# **HATFIELD BOROUGH PLANNING COMMISSION**

3. 23 N. MAIN STREET ARBOR GROVE  
DEVELOPMENT SKETCH PLAN  
PRESENTATION

Date: October 31, 2022  
To: Jaime E. Snyder, Hatfield Borough Manager  
CC: Bob Heil, Hatfield Borough Zoning and Codes Official  
Kate Harper, Hatfield Borough Solicitor  
From: Chad E. Camburn, P.E.  
Subject: 23 N. Main Street Sketch Plan Review  
Bursich Project No.: HAT-01/228286

**RE: Traffic Engineering Review #1**  
Arbor Grove Development  
23 North Main Street  
Hatfield, PA 19440  
McMahon Project No. 822C52.1A

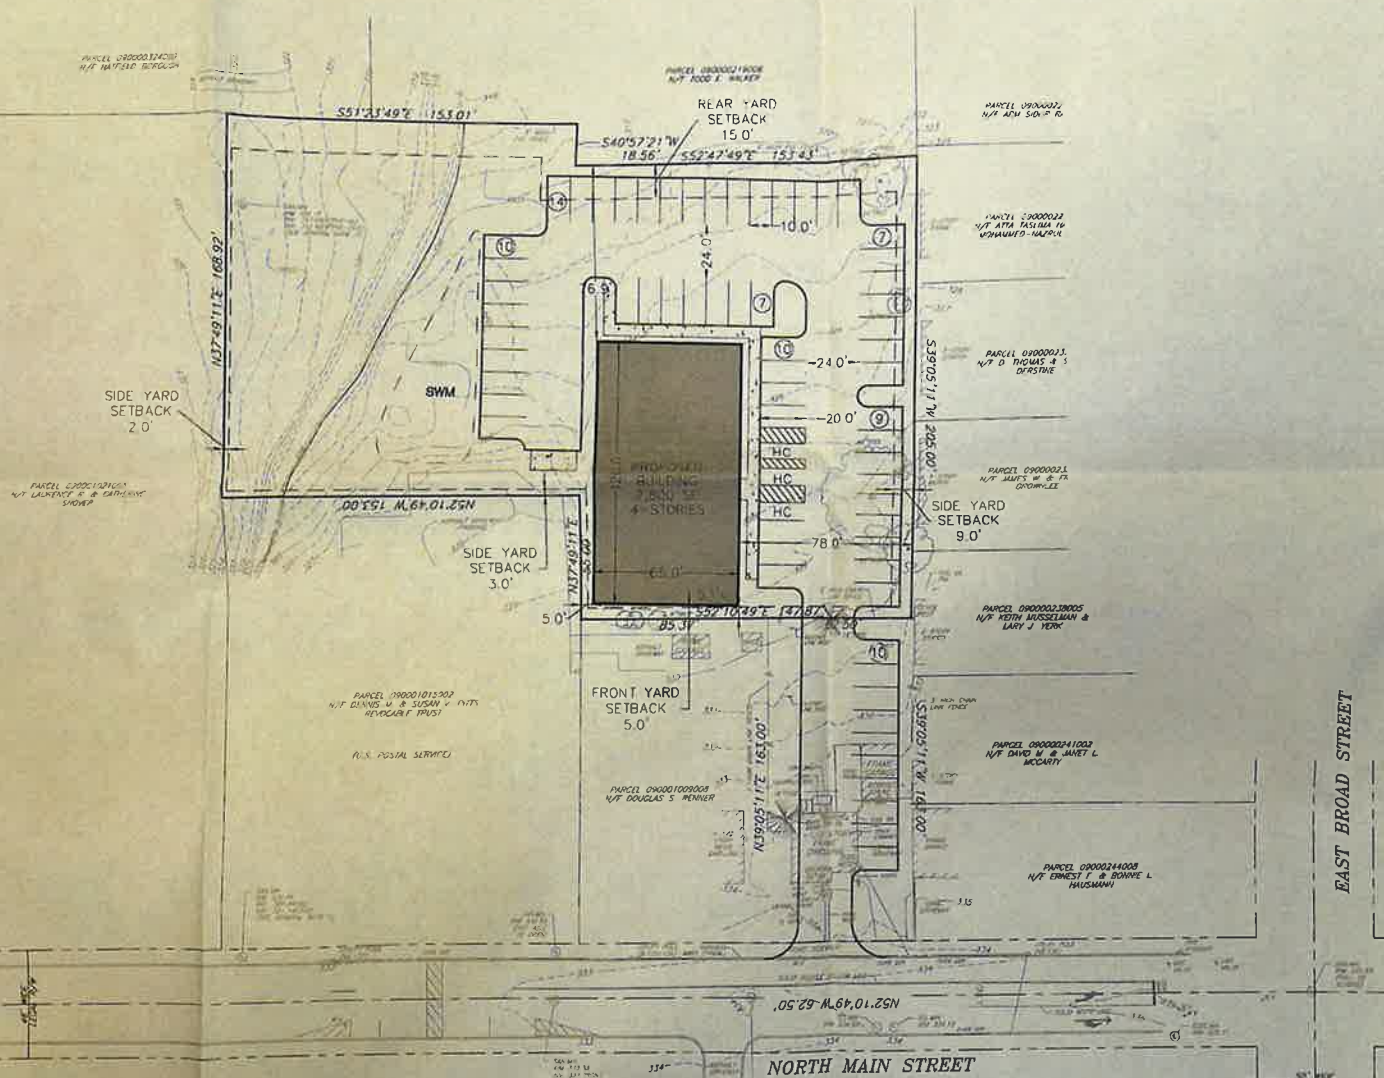
1. **§27-804** – Minimum lot width or frontage as required under this chapter shall be measured at the ultimate right-of-way line of the street. All lots must have sufficient frontage on a public or private street to meet the minimum lot width requirements of the zoning district.

***The existing landlocked parcel is existing non-conforming with respect to lot dimensions.***

2. § 27-805 - All front yard setbacks required under this chapter shall be calculated from the ultimate right-of-way of the street on which the lot fronts.

***The proposed building is on a landlocked parcel with no frontage along a street right-of-way. It is our opinion that the front yard would apply to the property line parallel to the street, which, in this case, would be the rear yards of the post office property and an existing dwelling property owned by a third party. If the two parcels were to be joined in common deed, then a determination of the front yard would be needed from the Zoning Officer.***

***If the two existing parcel will not be joined in common deed, the parking lot on the existing dwelling lot would require a zoning variance.***

9. §27-2108.1.E - Maximum allowed building height is four stories or 40 feet, whichever is more restrictive.
10. §27-2108.1.H - Front yard depth: five feet minimum, 10 feet maximum, and no new off-street parking spaces on the lot shall be placed between the principal building and the street.

***The building in the sketch plan appears to be in compliance with the front yard setback if the parcels remain separate. If the parcels are joined in common deed, the building may be considered to be beyond the maximum 10 feet front yard setback line. In either instance, the parking lot would be non-compliant as it would be located between the principal building and the street.***

5. Turning radius model would be required to confirm that fire apparatus would be able to navigate the turns of the parking lot.
6. The proposed fire lane is twenty-four (24) feet in width. Table D103.4 requires a minimum width of twenty-six (26) feet for aerial fire apparatus (ladder truck). The proposed four-story building would require aerial access to all side in the event of an emergency.

7. Due to the length of the proposed dead end fire lane a fire apparatus access road turnaround must be provide.

1. A traffic assessment of the proposed access onto North Main Street should be completed by the applicant. The proposed development access is located in close proximity to the signalized intersection of Main Street and Broad Street, and the interaction between the left turn ingress movements, the eastbound left turn lane for the traffic signal, Grace Lutheran Church access, and existing pedestrian crossing should be evaluated.
2. Pedestrian access to the site should be provided and ADA compliant curb ramps must be provided at the access for the existing sidewalk. It should also be noted that the Borough has identified traffic calming\pedestrian improvements along North Main Street at the existing pedestrian crossing for the post office.
